DRAFT- DOH Review:
Navy Groundwater Flow Models & Related Issues with
the Navy CSM for the Red Hill Facility

The Department of Health Hawaii (DOH)
Technical subject matter experts
Robert Whittier, Don Thomas, G.D. Beckett & Anay Shende

October 19, 2021

Gradient beneath and downslope of the tanks

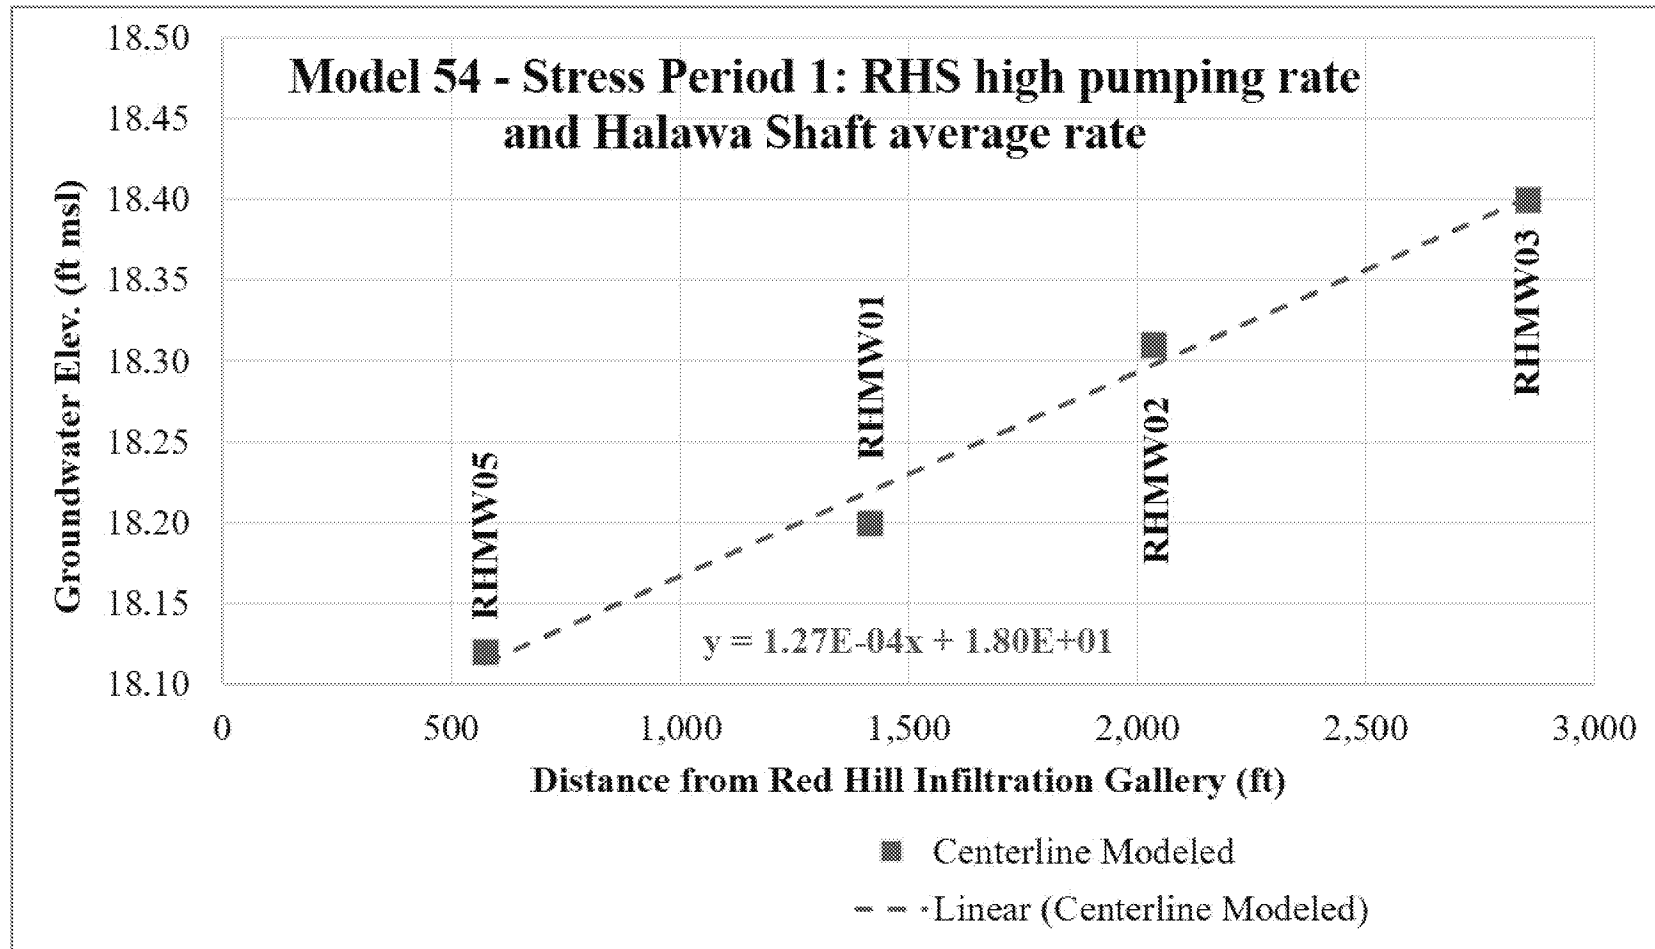
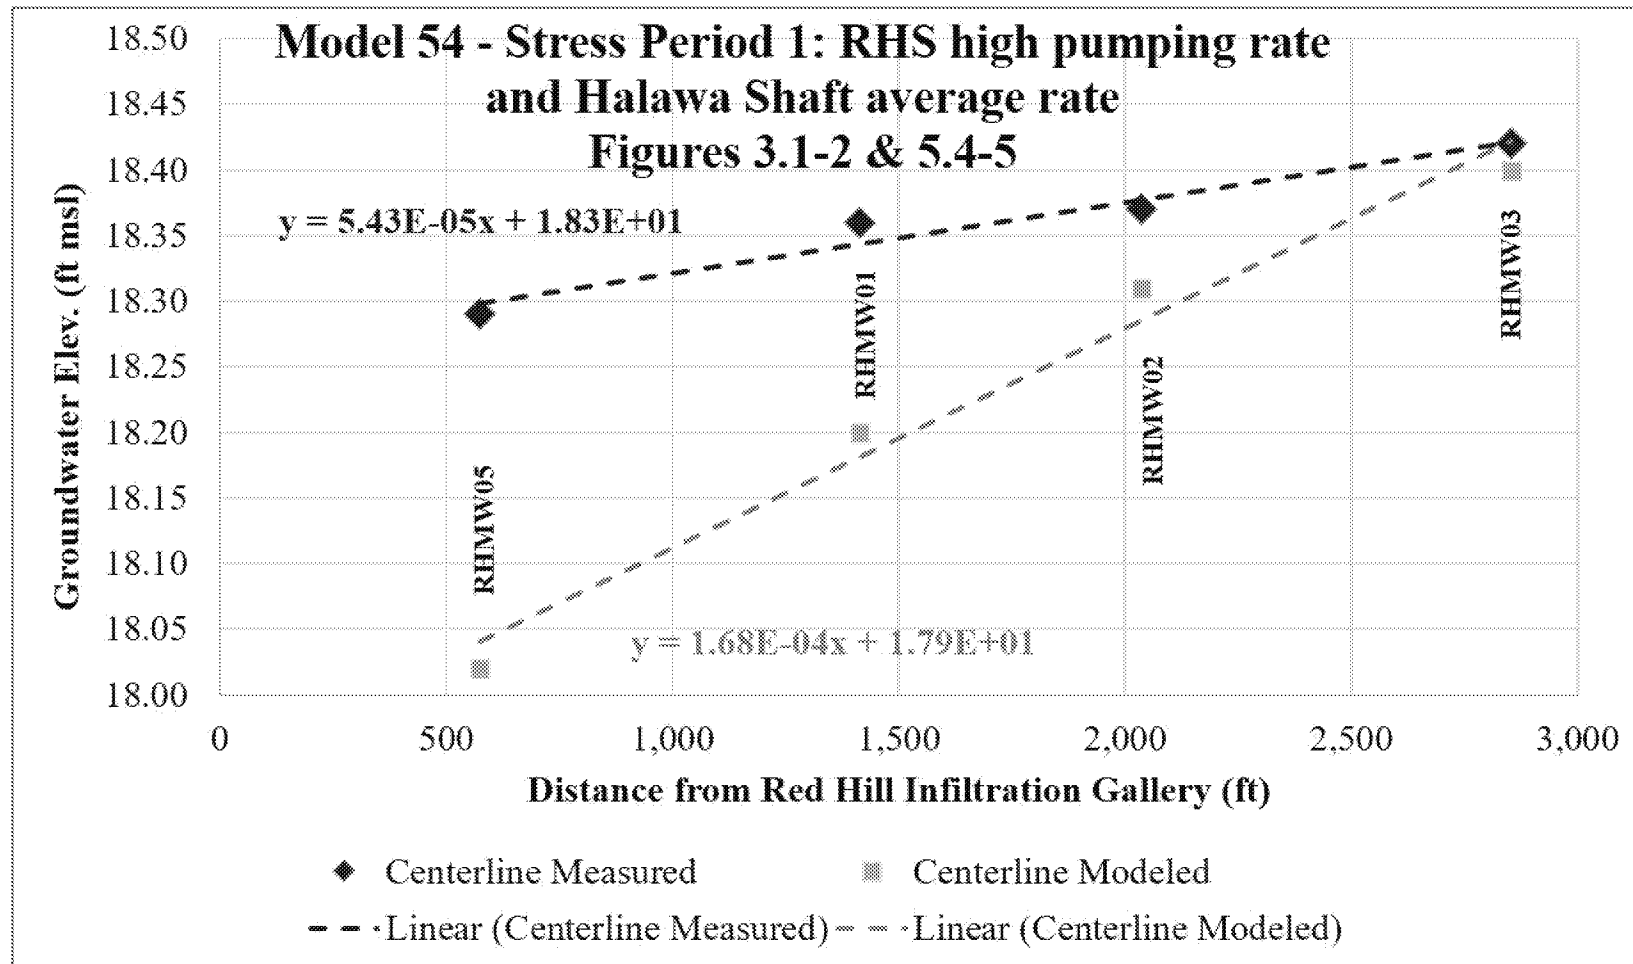
1. Metrics currently used
 - a) Groundwater elevations
 - b) Transient responses
 - c) Others
2. Concern with current comparative data
 - a) Mis-match between modeled and measured gradients
 - b) Groundwater elevations have low accuracy
3. Alternative groundwater behavior data
 - a) Chloride and other natural tracers

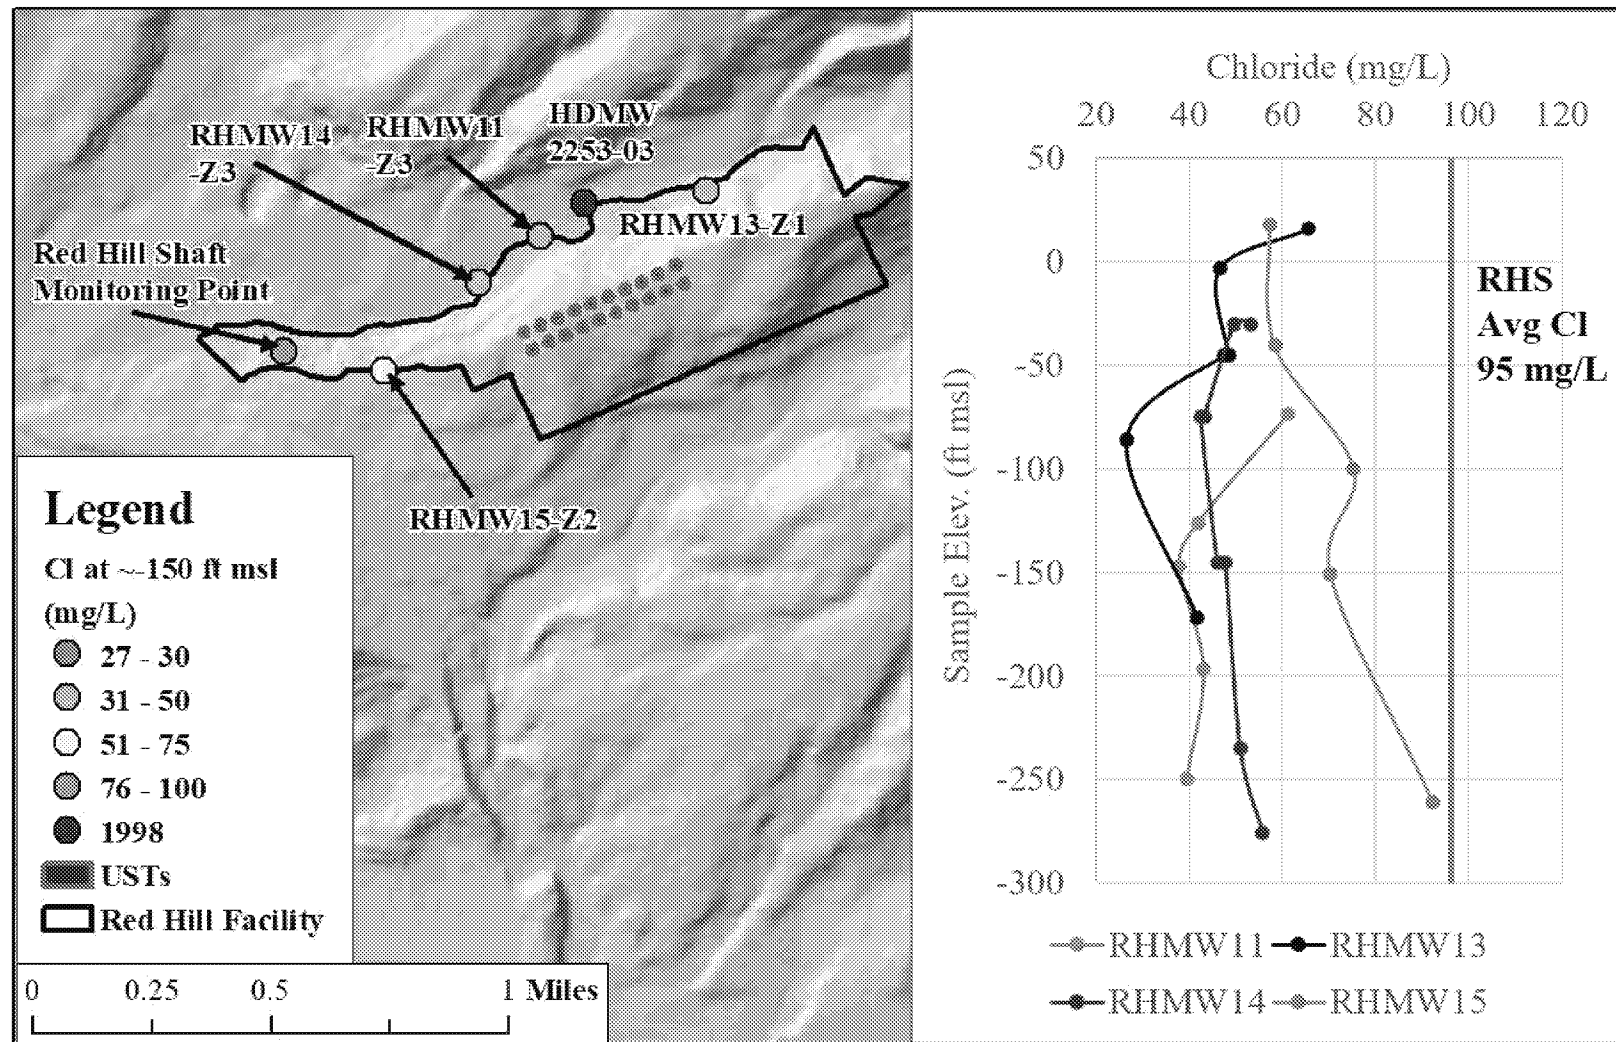
It is unlikely that chlorides originating in the Halawa region elevated the chloride concentration in the RHS

GW Elevation Variance – Transient Models

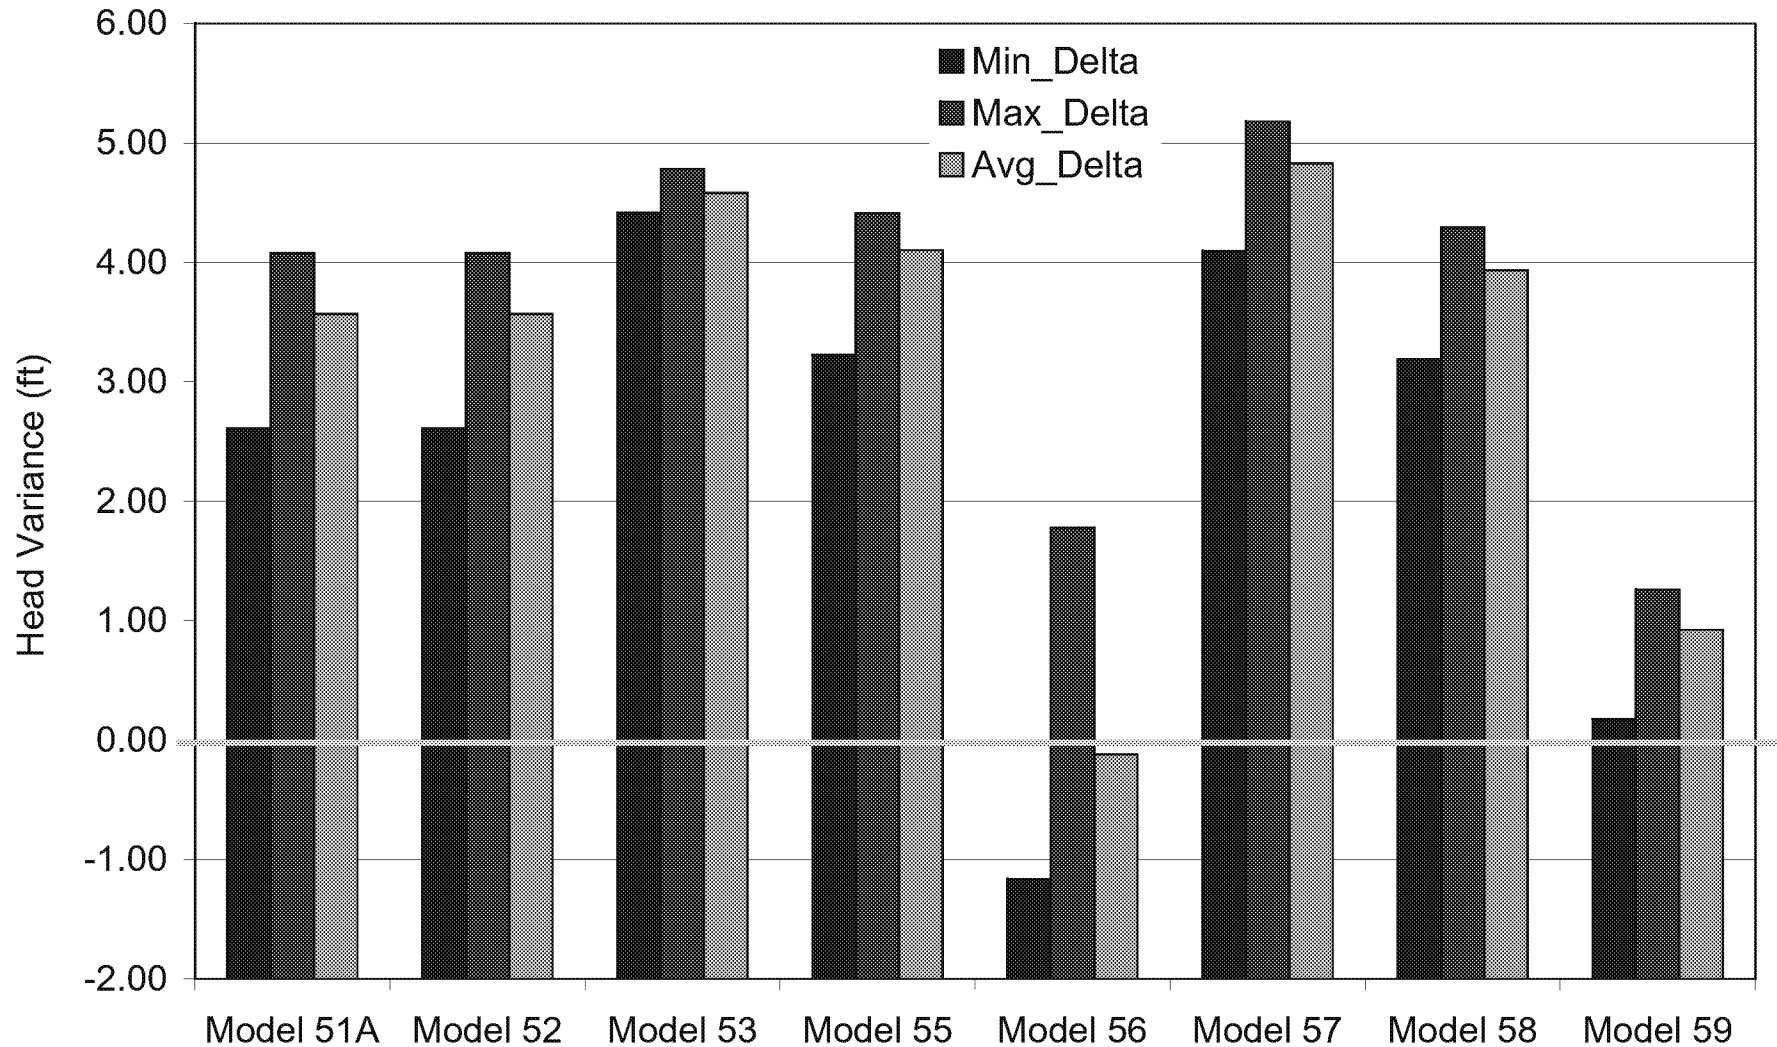
Modeled Groundwater Elevations Compared to Actual Synoptic Data
Verification Model Variances to Measured Red Hill Area Well

Non-Uniform Distance Drawdown Behavior

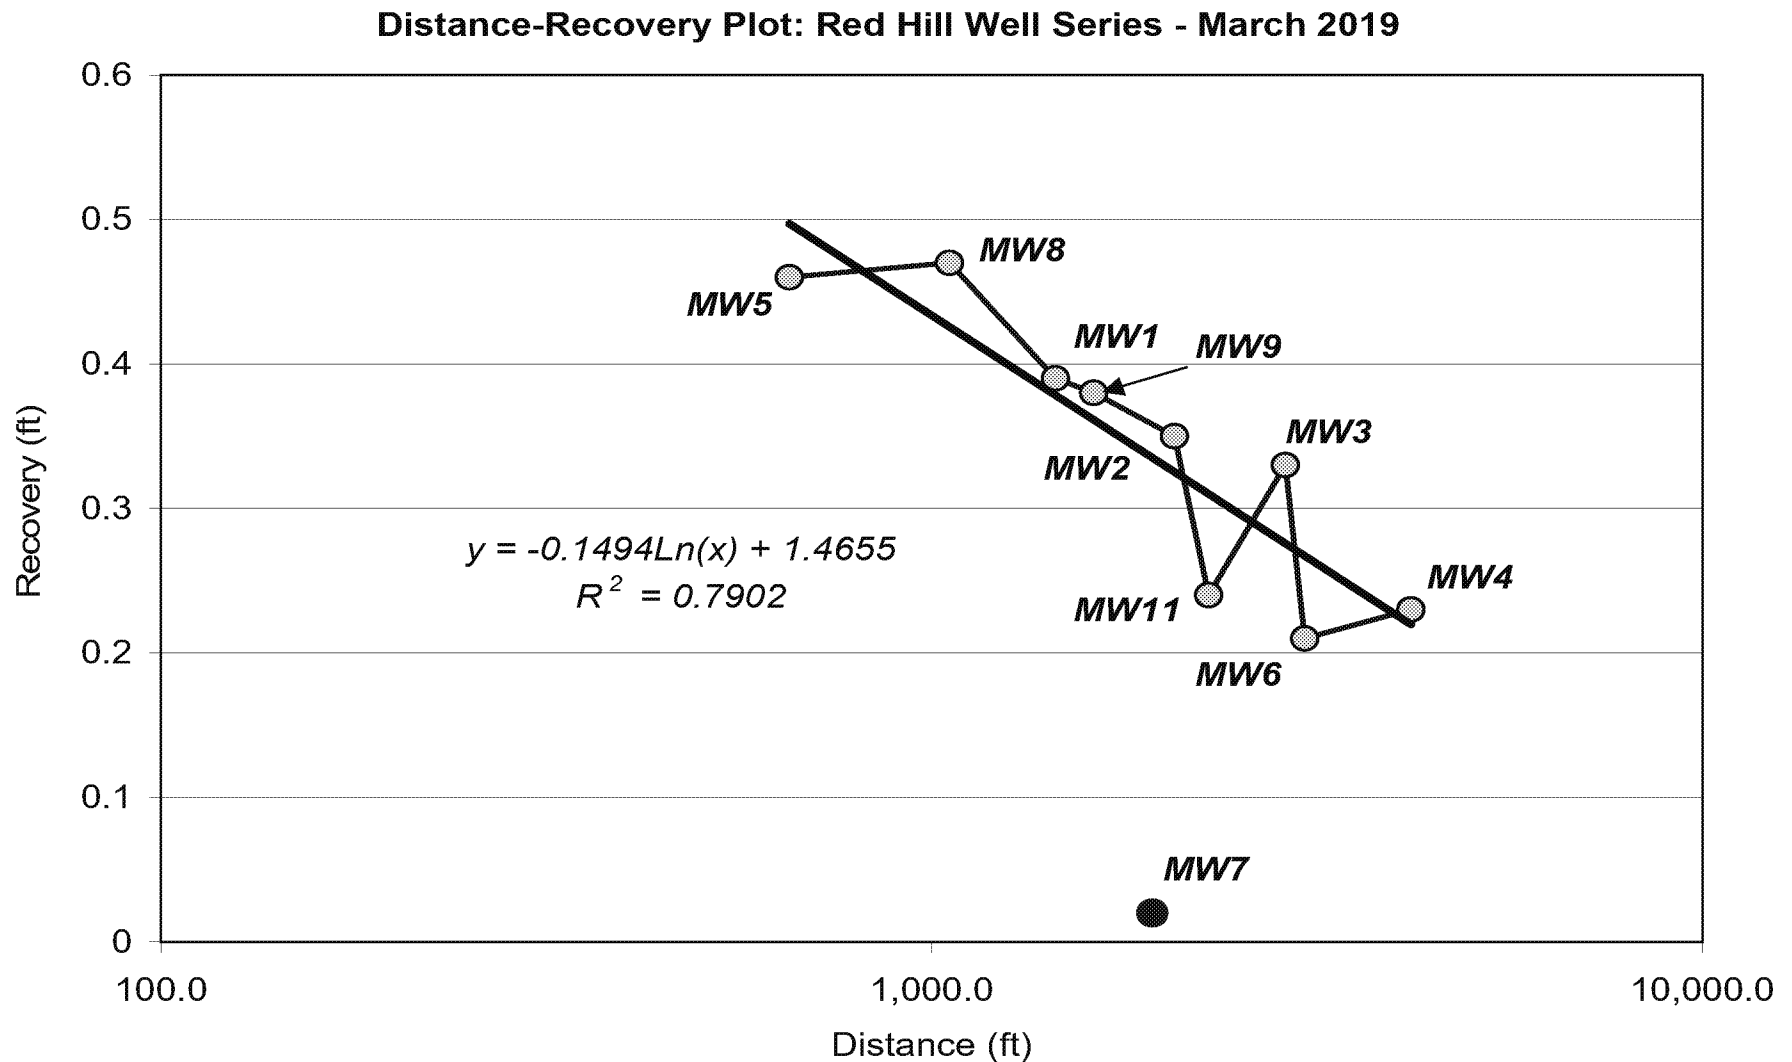
(indicates complexities not captured by models)

Lab vs. Field Scale – Permeability

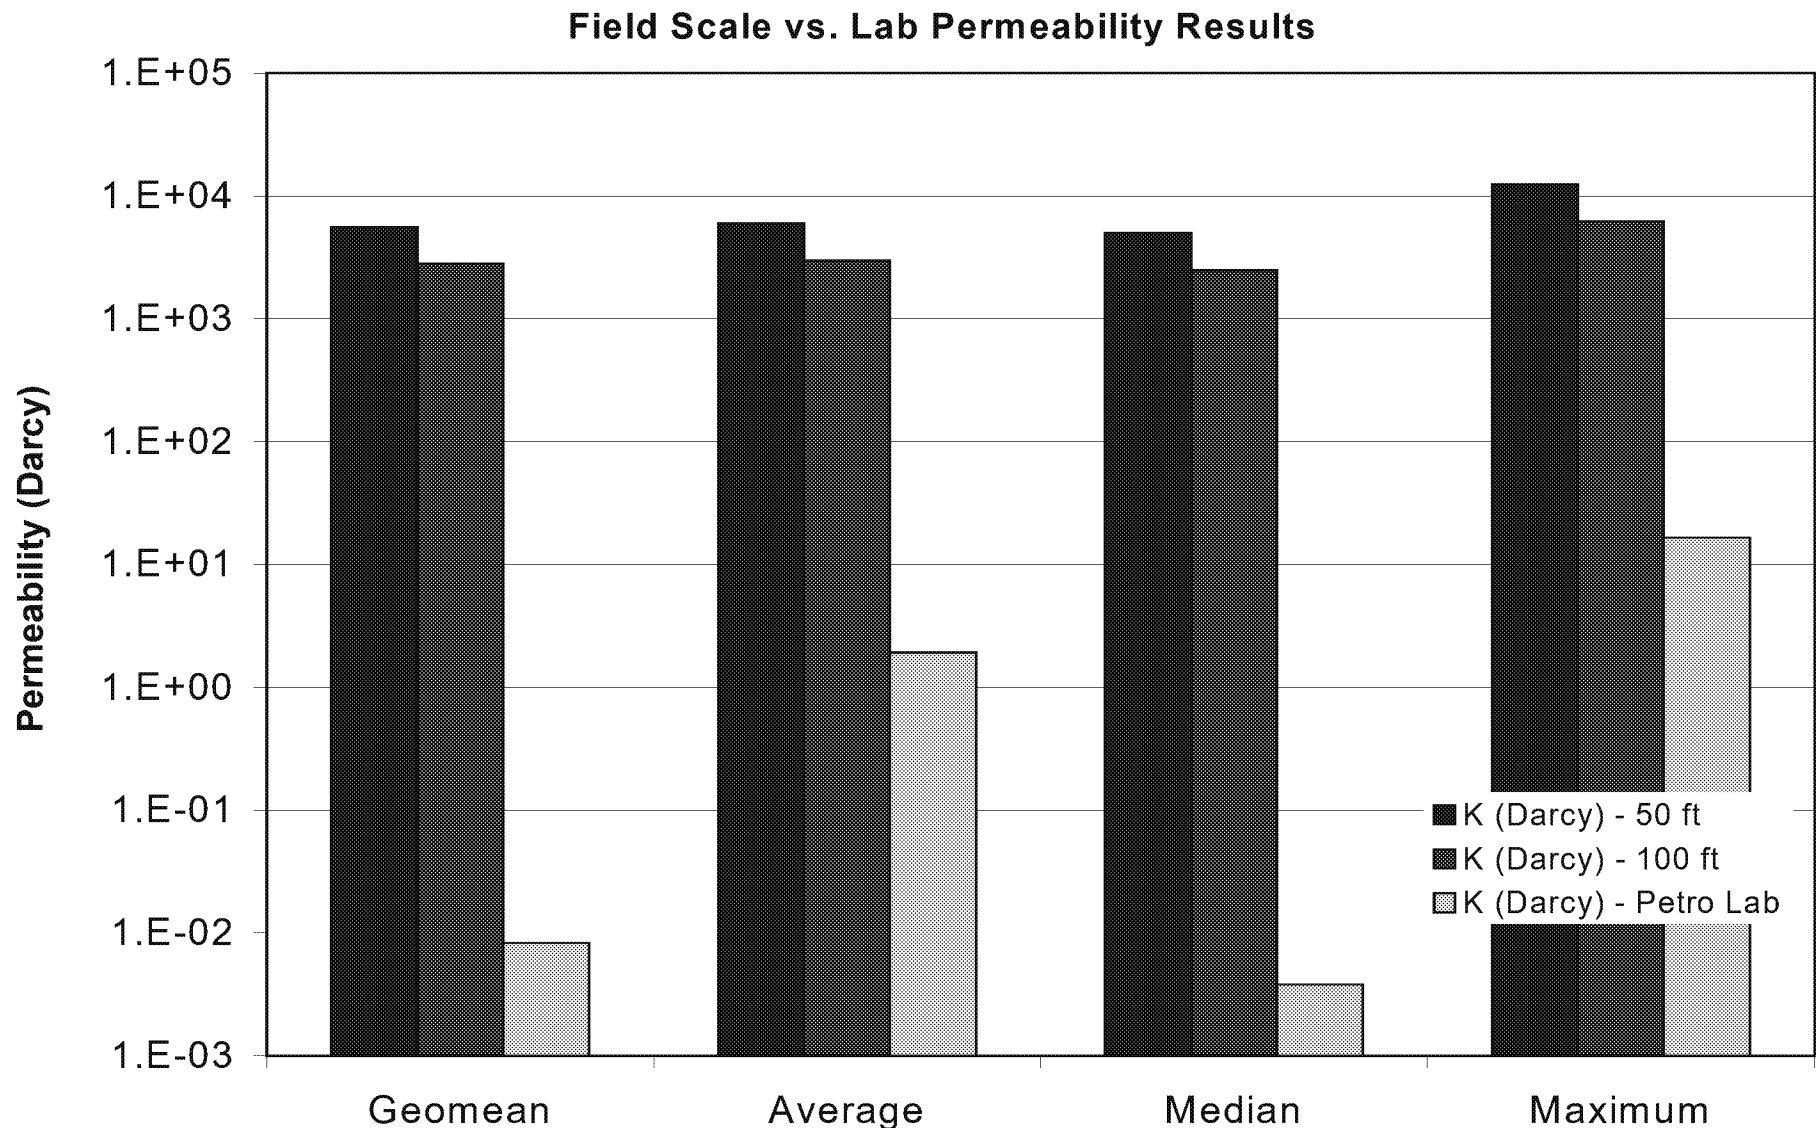
(Site lab data vastly under-represent field scale permeability)
